SAN FRANCISCO PLANNING DEPARTMENT

Certificate of Appropriateness Case Report

Filing Date: May 30, 2018
Case No.: 2017-015622COA
Project Address: 925 PIERCE STREET
Historic Landmark: Alamo Square Landmark District
Zoning: RH-3 (Residential-House, Three Family)
40-X Height and Bulk District
Block/Lot: 0776/001
Applicant: Serina Calhoun
Syncopated Architecture
657 Fillmore Street
San Francisco, CA 94117
Staff Contact Jonathan Vimr – (415) 575-9109
jonathan.vimr@sfgov.org
Reviewed By Tim Frye – (415) 575-6822
tim.frye@sfgov.org

DEMO/NEW
GROUND FLOOR

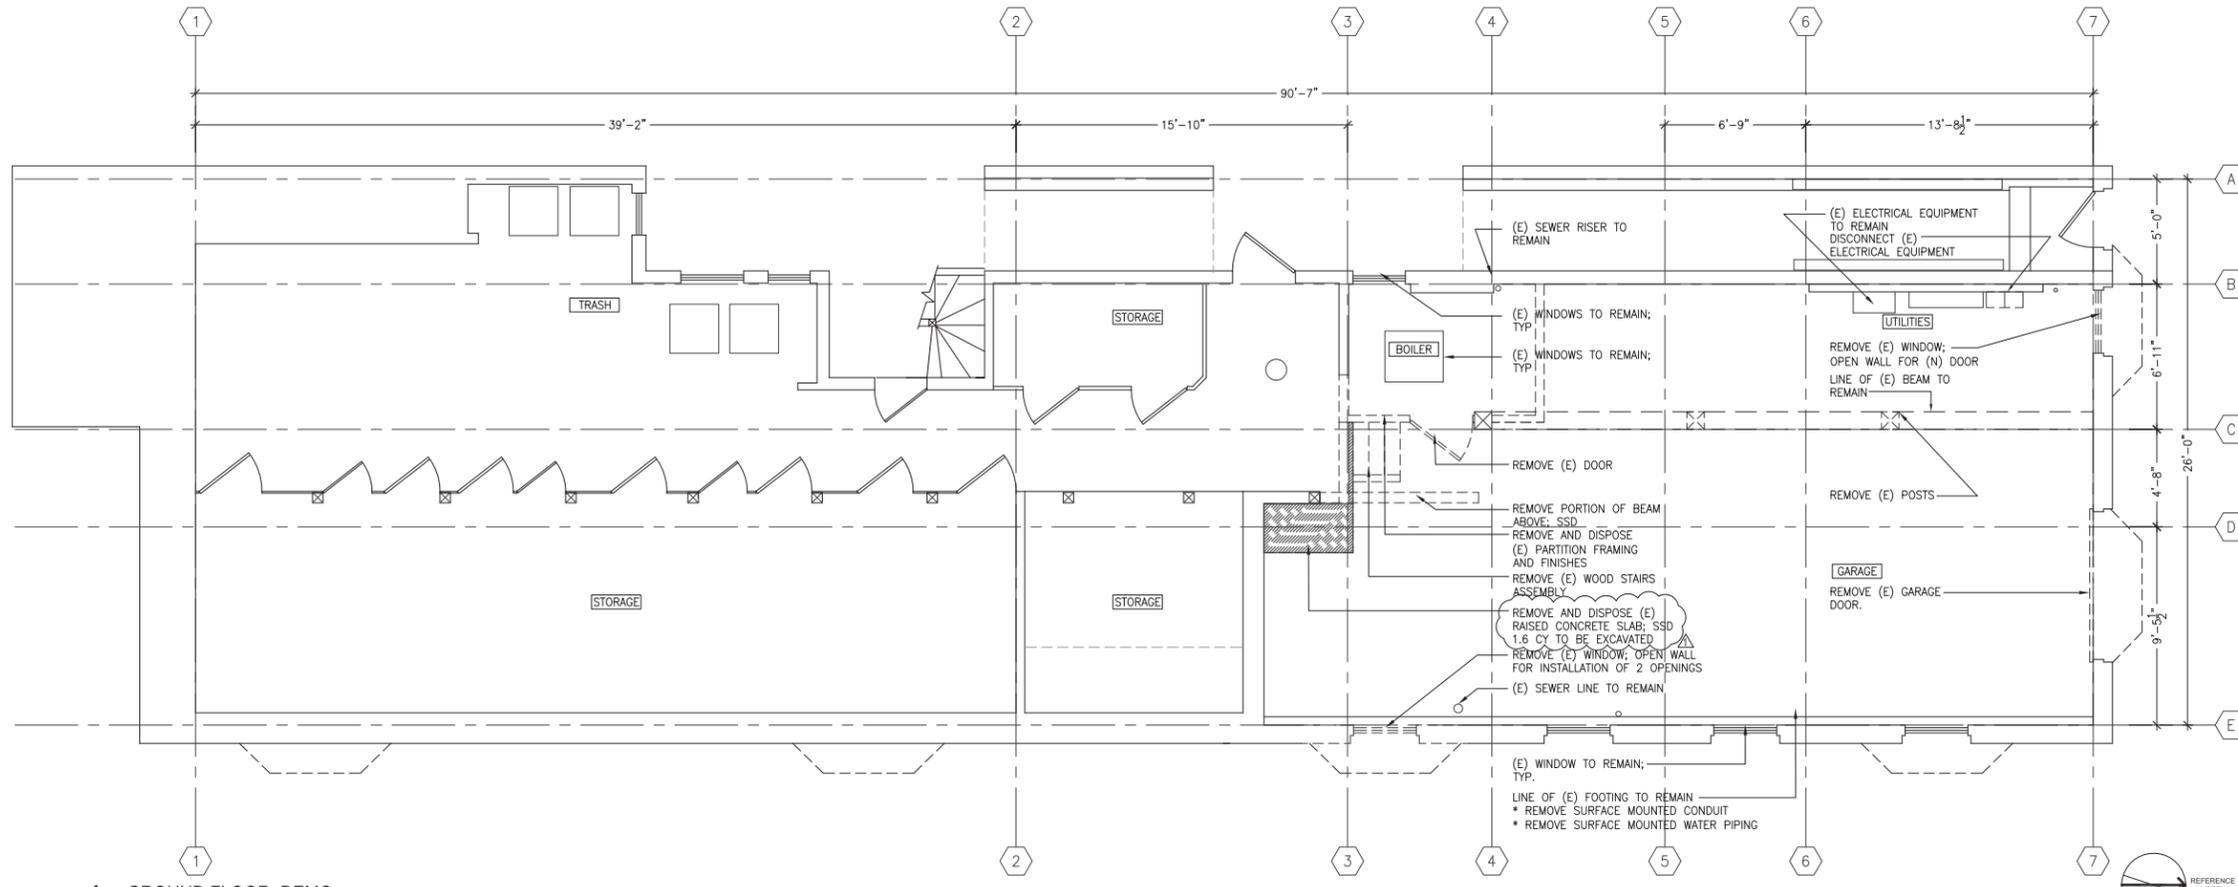
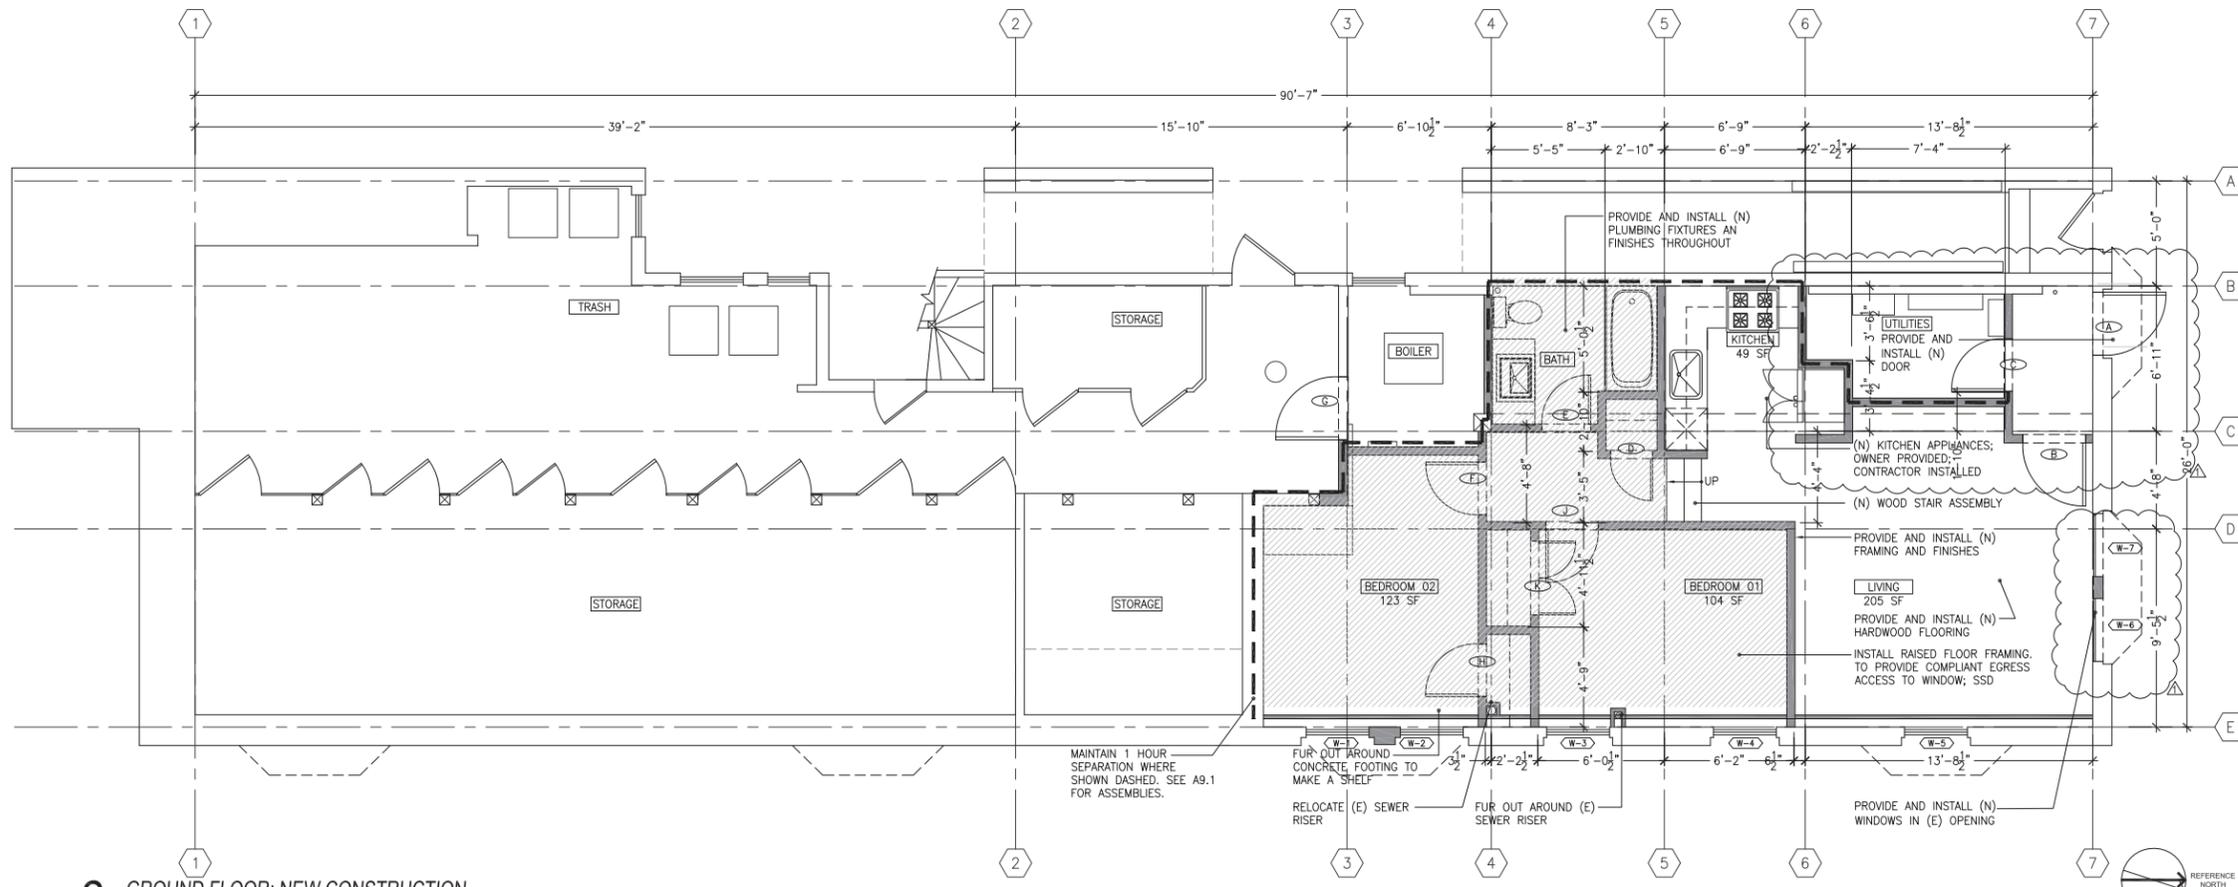
The project will involve the removal of a limited amount of historic brick at the base of the building in connection with the modifications to the ground level window openings. Having said that, the total removal will entail very little brick, all of which is non-ornamental in contrast to the decorative brickwork found at the upper levels.

A3.5

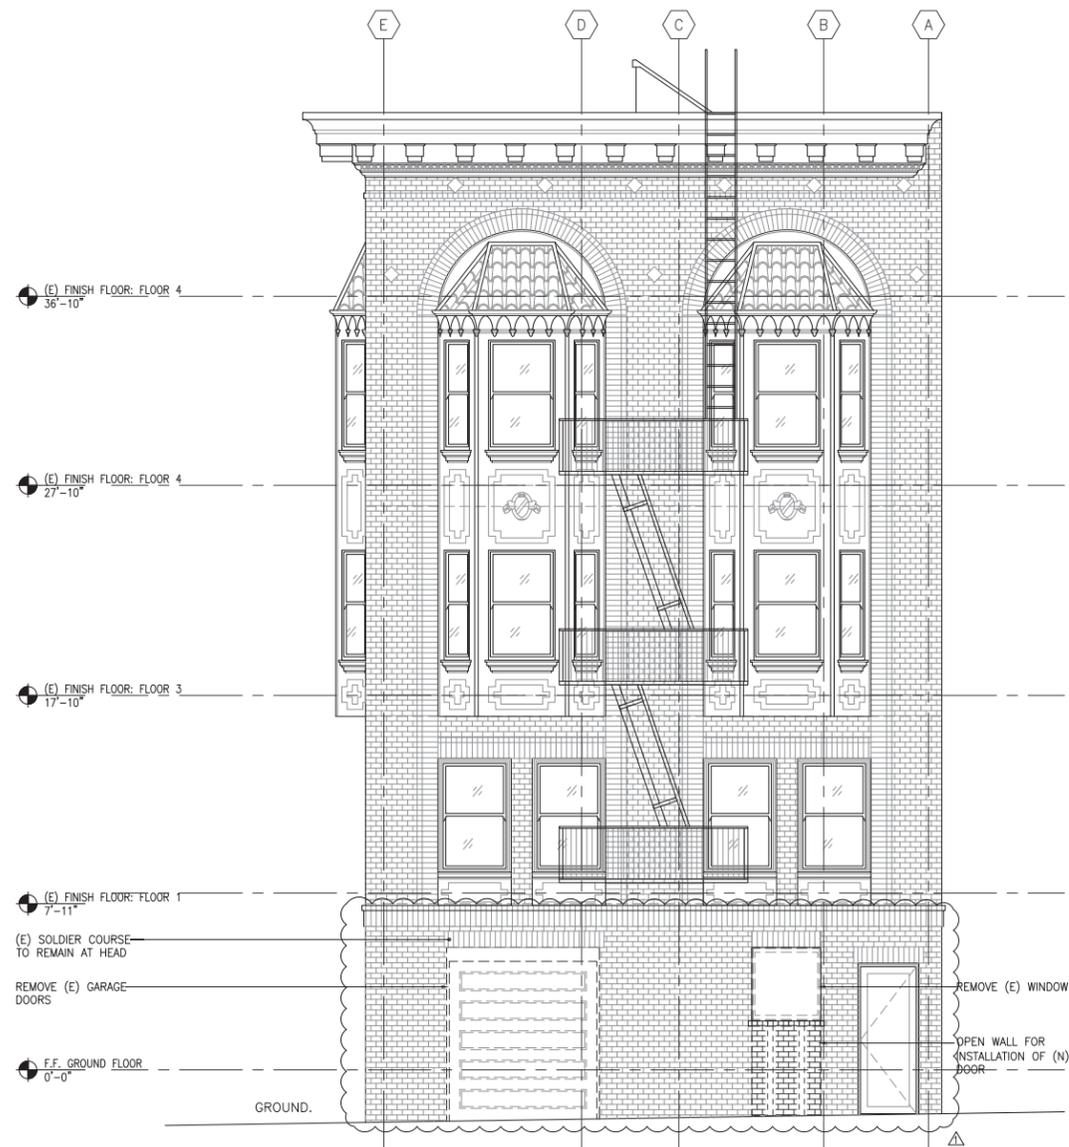
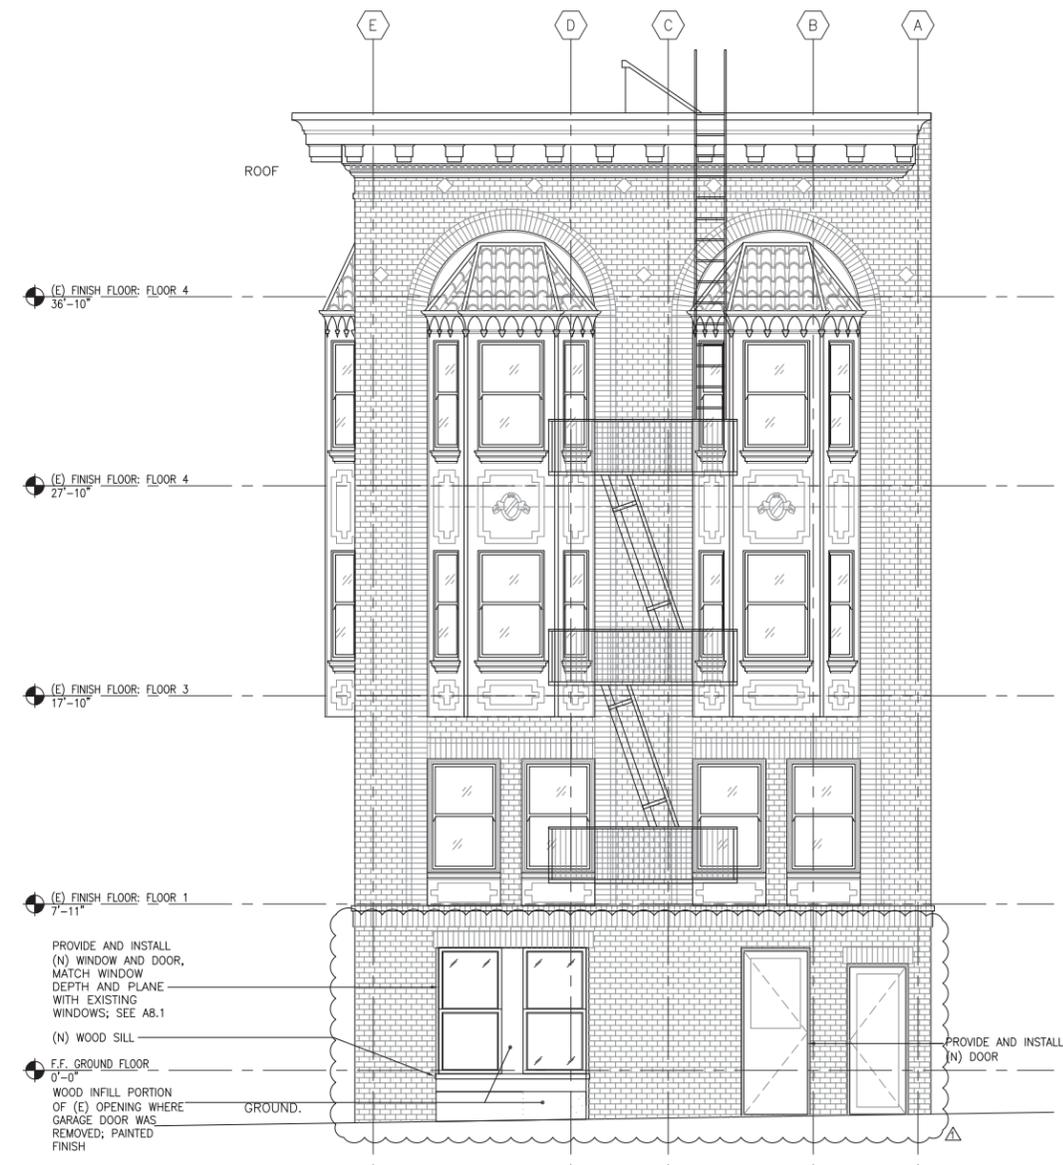
As proposed, the project would affect none of these elements. The garage opening to be modified, while likely original to the building, is not a character-defining feature and as such the proposed alterations will not destroy historic materials, features, and spatial relationships that characterize the property. The new wood double-hung windows and infill system will be compatible with the property, as wood is a ubiquitous material within the District that also manages to provide differentiation from the surrounding brick, and the double-hung windows will match the material and operation of historic windows while achieving differentiation due to the lack of ogee lugs and their placement within the inset infill system. Compatibility will be further achieved through the alignment of the new double-hung windows with those at the upper levels.

Both the replacement windows along Pierce Street—and the one new window—as well as the new door at the Golden Gate Avenue façade will be composed of wood. This again reflects the appropriate material for the property and District at large, as is reflected in the designating ordinance.

- The project will ensure that the new wood windows at the ground floor of the Golden Gate Avenue façade will be compatible with the historic windows in that they will match the materials, operation, and alignment, while being differentiated from the historic windows due to their lack of integrated ogee lugs and their location within the punched garage opening infill.

1. As part of the Building Permit, the project sponsor shall provide final details regarding the attachment of the garage infill system with existing building reveals to Planning Department preservation staff for review and approval.

2. As part of the Building Permit, the project sponsor shall contact Planning Department preservation staff to arrange a site visit for the review and approval of a mockup of the wood infill system's attachment to an existing building reveal.
3. As part of the Building Permit, material samples for any replacement brick that may be needed shall be provided to Planning Department preservation staff for review and approval.
